Access Compliance Report Public Rights-of-Way (Curb Ramps)

Intersection ID: 47400 Main Street: OVERLAND PARK LN Cross Street: FLAT_RIVER_DR Location: SW ADA ID: 8A3E9188D308 Ramp Type: Perp Initial Pass/Fail: Fail **Overall Compliance: No Severity Score:** 22.5

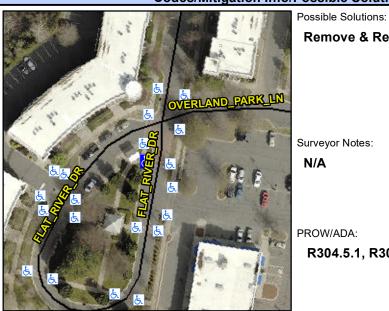
Field Measurements/Component Compliance					
Compliance Description		Data	Compliance Description		Data
N/A	Ramp Length (in)	68.5	No	Ramp Slope (%)	11.6
No	Ramp Width (in)	44.0	No	Ramp XSlope (%)	2.6
N/A	Flare Type LT	N/A	N/A	Flare Type RT	N/A
N/A	Flare Slope LT (%)	N/A	N/A	Flare Slope RT (%)	N/A
N/A	Flare Traversable LT?	N/A	N/A	Flare Traversable RT?	N/A
N/A	Landing Length (in)	N/A	N/A	DWS Provided?	N/A
N/A	Landing Width (in)	N/A	N/A	DWS Contrast?	N/A
N/A	Landing Slope (%)	N/A	N/A	DWS Length (in)	N/A
N/A	Landing X Slope (%)	N/A	N/A	DWS Full Width?	N/A
N/A	Landing Curb? (Y/N)	N/A	N/A	DWS Offset (in)	N/A
N/A	Shared Landing?	N/A			
N/A	Gutter Ponding?	N/A	N/A	Gutter Slope (%)	N/A
N/A	Gutter Lip Ht (in)	N/A	N/A	Gutter X Slope (%)	N/A
N/A	Painted X Walk1?	Yes	N/A	Painted X Walk2?	N/A
	X Walk 1 Direction	To SE		X Walk 2 Direction	N/A
N/A	X Walk 1 Width (in)	51.0	N/A	X Walk 2 Width (in)	N/A
	X Walk 1 Slope (%)	0.5		X Walk 2 Slope (%)	N/A

Remove & Replace Entire Ramp. Surveyor Notes: N/A PROW/ADA: R304.5.1, R304.2.2, R304.5.3
